DATA-CENTER ADDENDUM #1

SEPTEMBER 27, 2022

ATTACHMENT A
DATA-CENTER ROOM

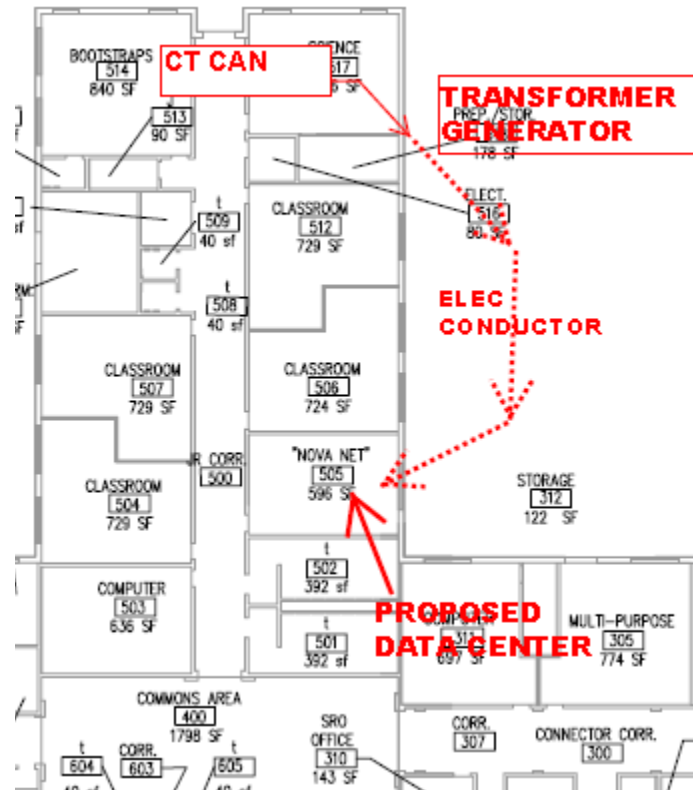
2. The location of the Data Center has changed, moving from Room # 503 to #505. See Attachment A.
3. The electrical utility will provide 480 V power to the Contractor-supplied CT Can which is to be wall mounted adjacent to the transformer. The contractor shall furnish (3) 15-ft runs of conduit suitable to service the transformer.
